Addendum 02

PROJECT: Fort Loramie Local Schools Athletic Complex Building & Associated Improvements
600 East Park Street
Fort Loramie, Ohio 45845

PROJECT #: 25041.00

SHEET NUMBER:
A0.3

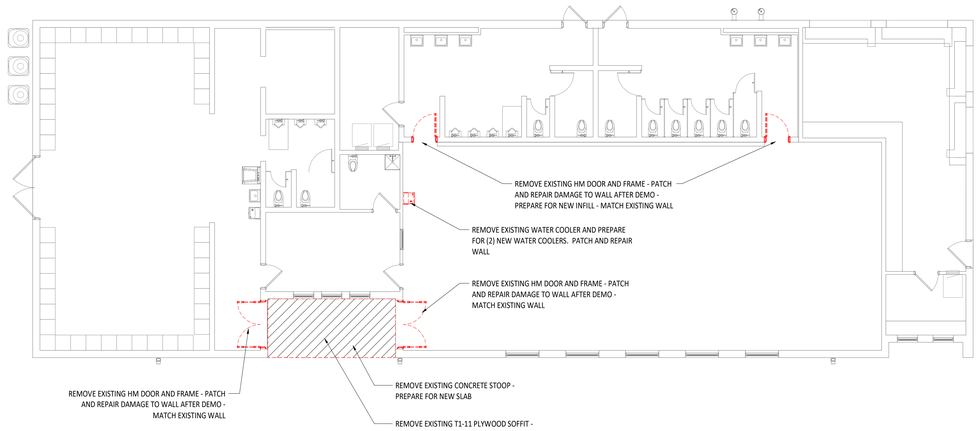
7.) A0.3 Typical Details – Added mockup wall detail
8.) A1.1 First Floor Plan – Remove 4" CMU partial height walls and adjust overlapping elevation tags

EXTERIOR ELEVATIONS COLORED

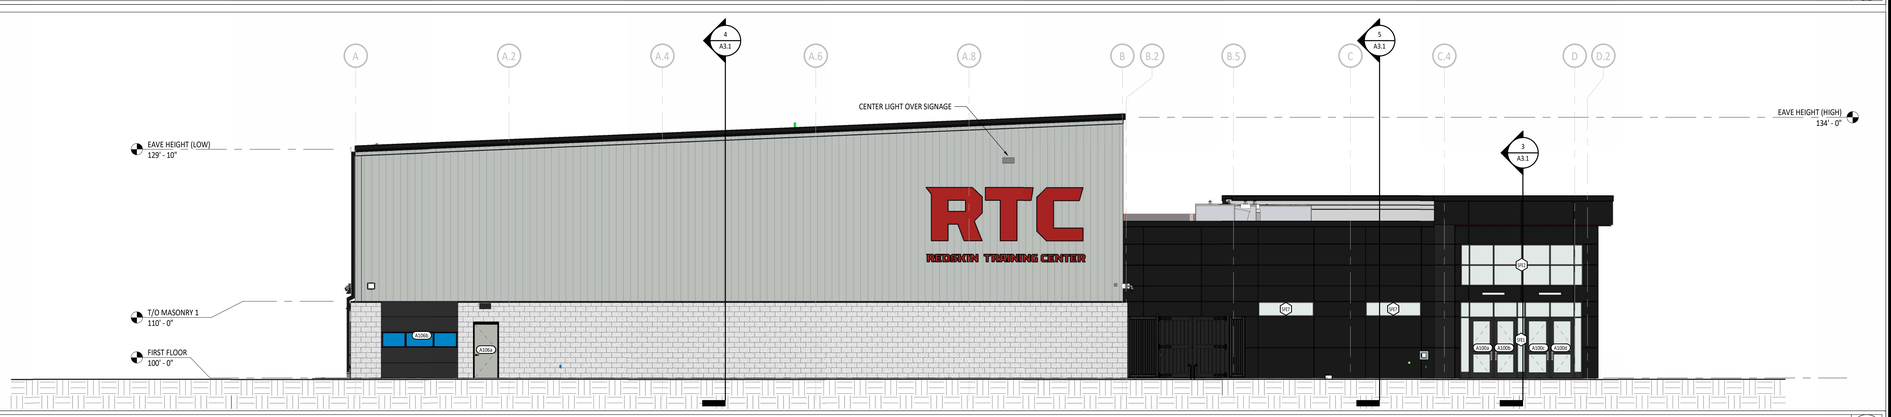
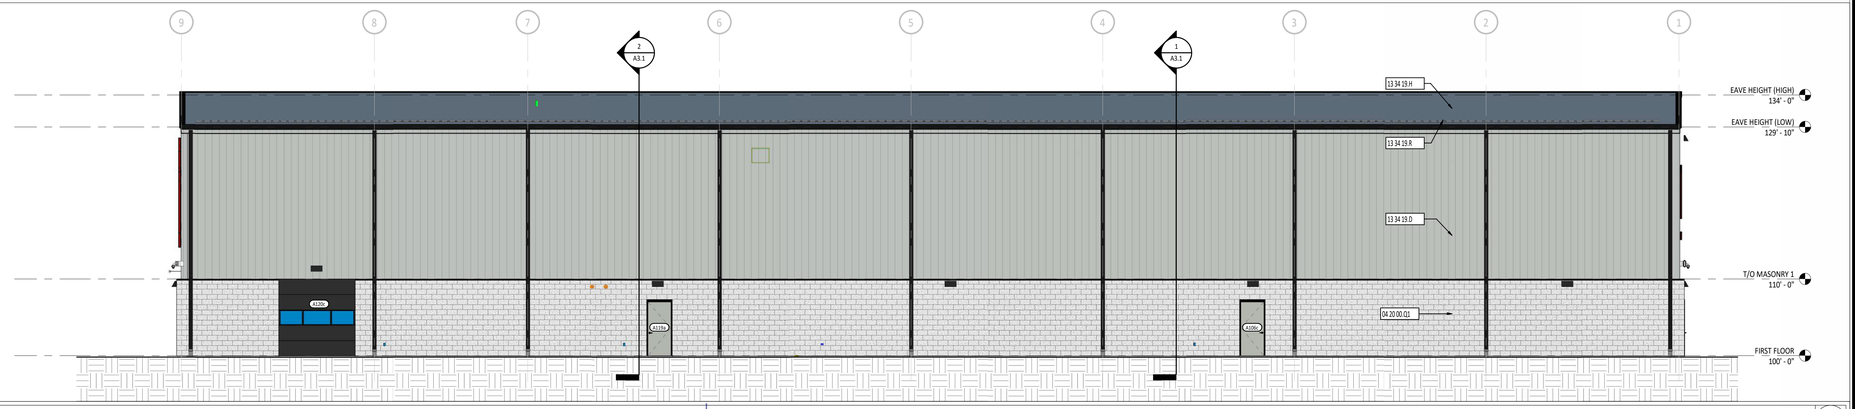
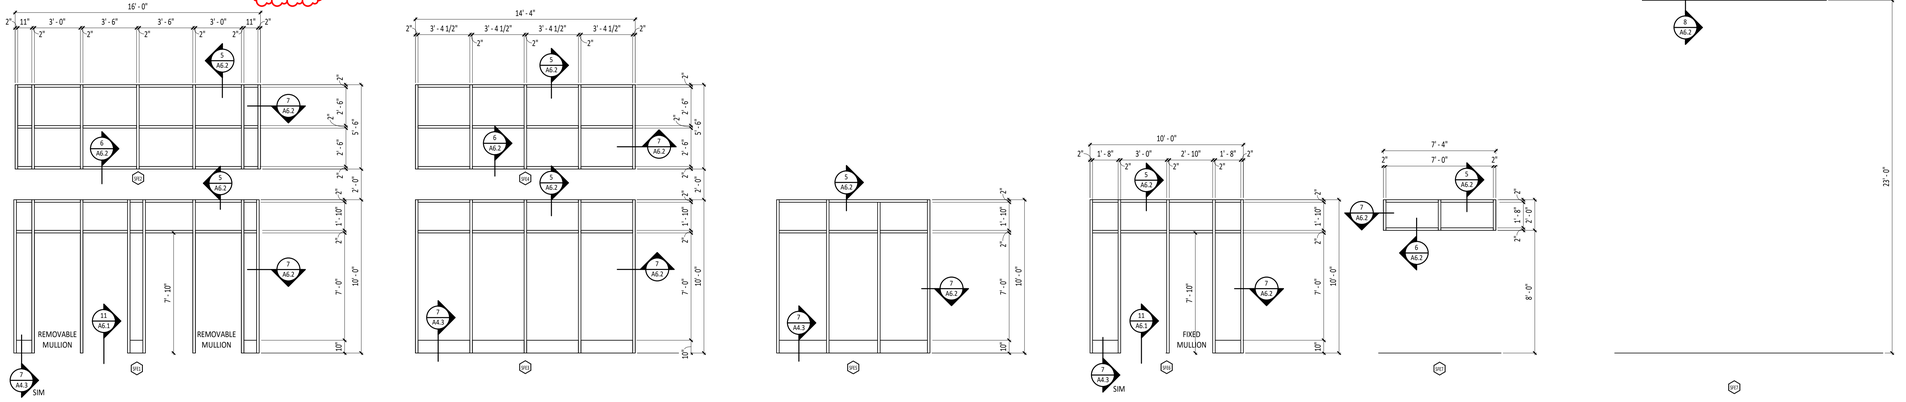
11.) A2.2 Exterior Elevations – Colored – Added sheet to drawing set
12.) A6.2 Storefront & Door Elevations / Details – Added glazing types to the storefront schedules to clarify locations of different glazing. Reference 08 80 00 spec section for descriptions of glazing types.

23. Sheet A1.1 references and elevation on sheet A2.2. Does not exist.
    a. **Response: Addressed in Addendum 2. Sheet A2.2 has been added to set and overlapping tags have been adjusted**

1 A8.1 **FIRST FLOOR EQUIPMENT PLAN**
1/8" = 1'-0"

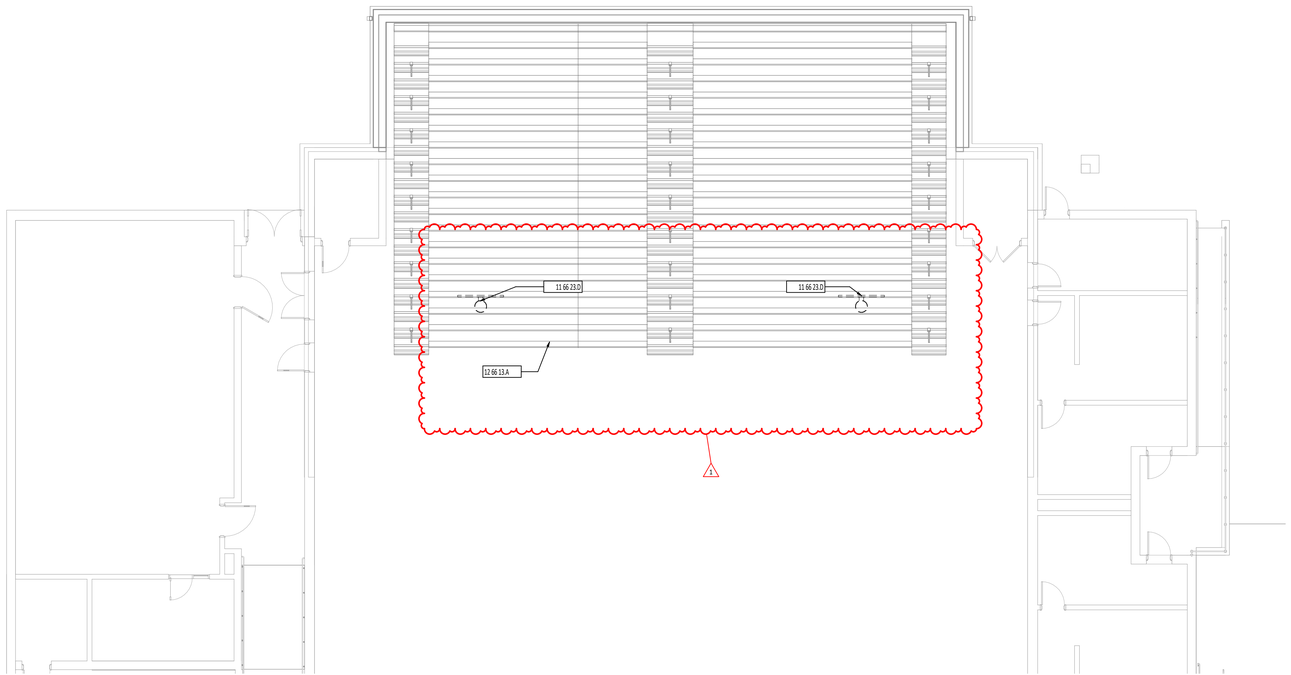
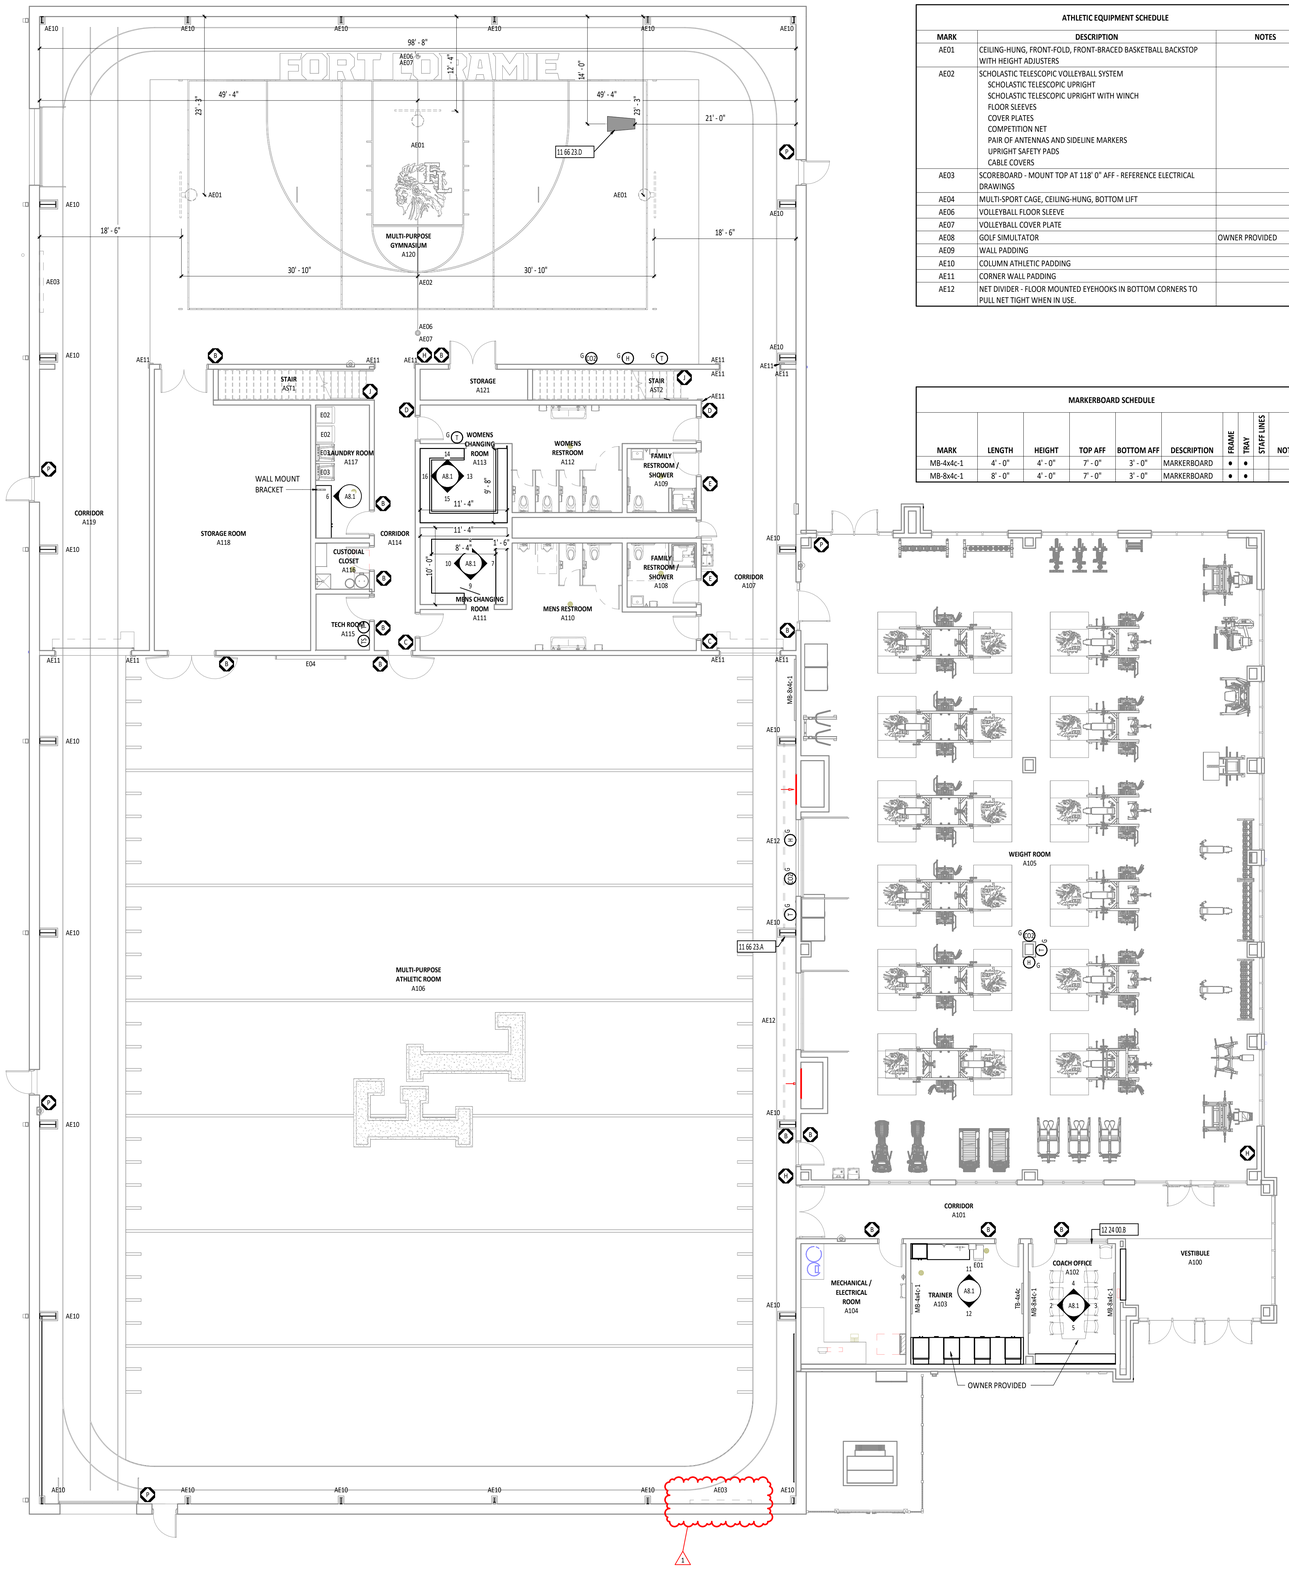
13.) A8.1 First Floor Equipment Plan – Revised location of scoreboard in A106
14.) A9.0 – Revised flooring transition detail
    a. Eliminate FLT3 floor transition detail from the Finish Material Schedule.

SHEET NUMBER:
E4.1

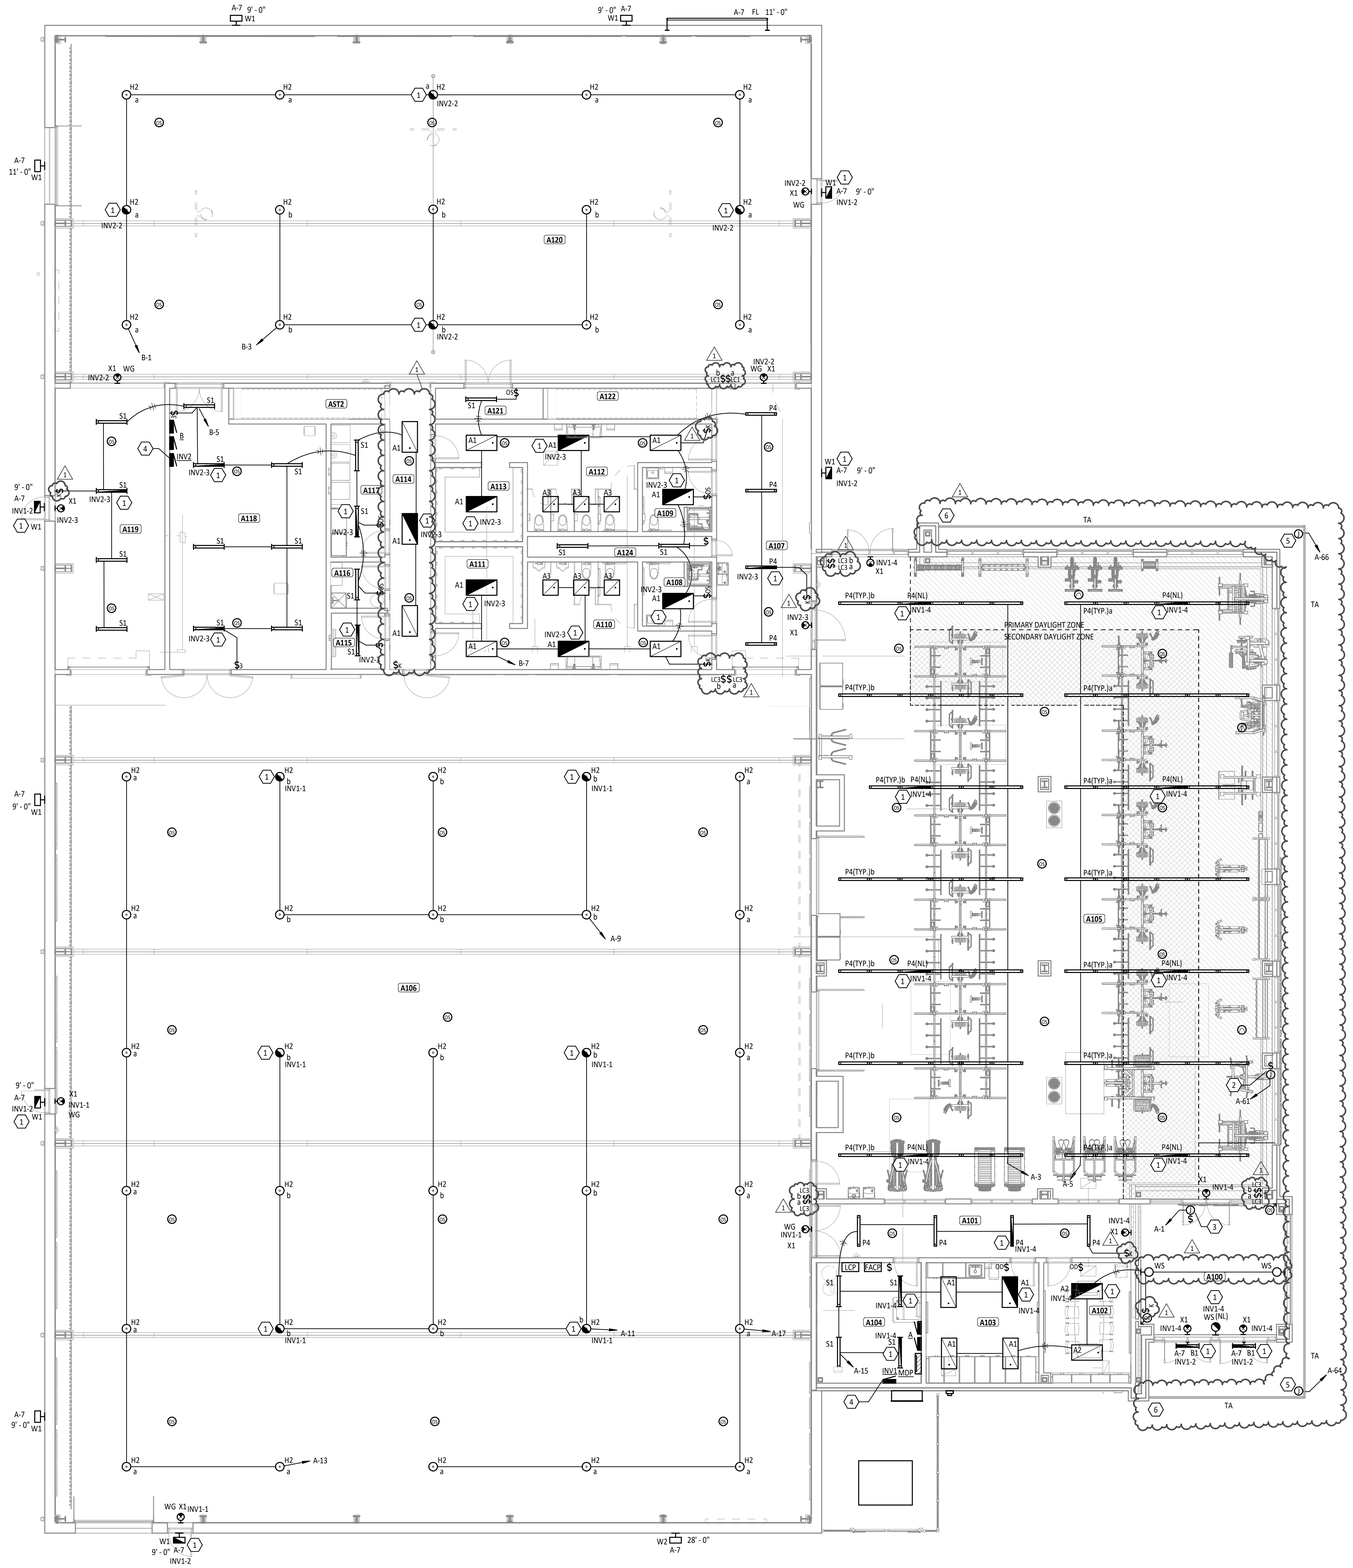
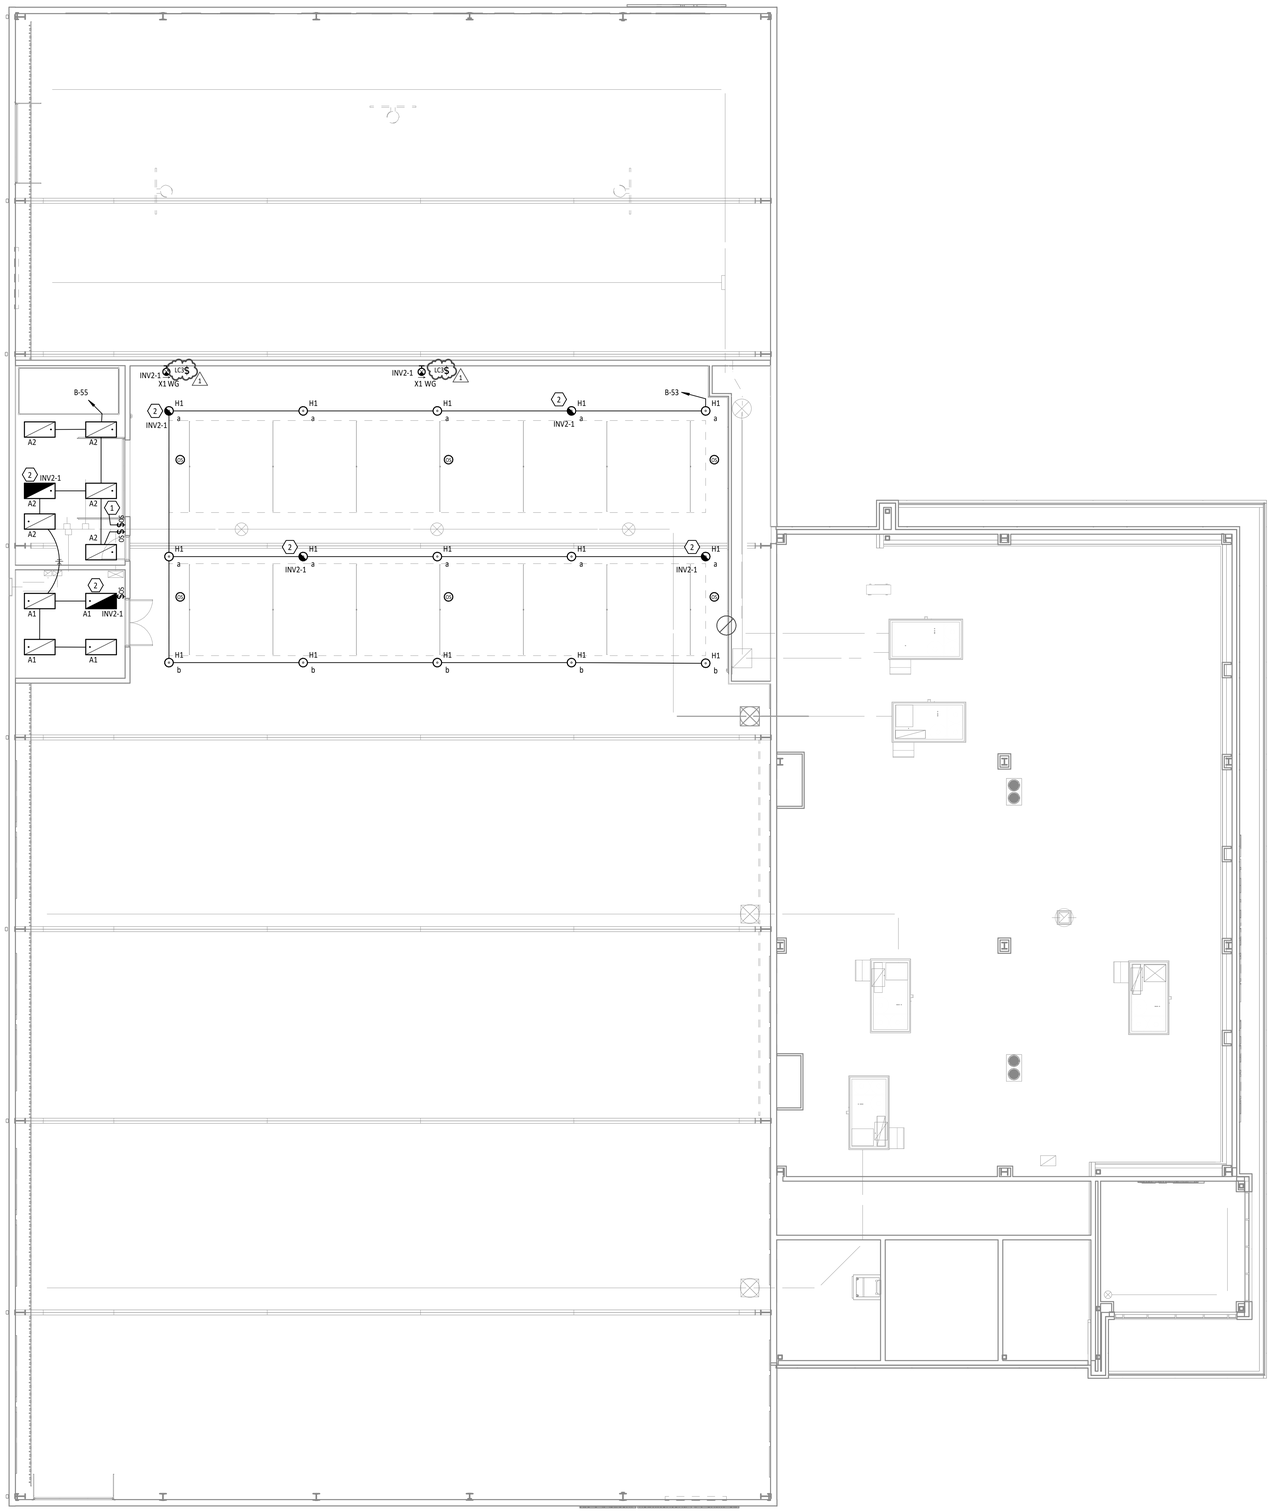
b. Update lighting control symbols to have manufacturer and product numbers called out.
24.) E4.1 First Floor Lighting Plan
    a. Revised light fixtures in A114

b. Revisions to the 'TA' lighting on the exterior of the weight room area.
    c. Added a key switch and circuit lines in A100.

d. Added a key switch in A101.
e. Added and updated lighting control switches in A105.
f. Added and updated lighting control switches in A106.
g. Added a key switch in A107.
h. Added a key switch in A110.
i. Added a key switch in A112.
j. Added a key switch in A114.
k. Added a key switch in A119.
l. Added and updated lighting control switches in A120.
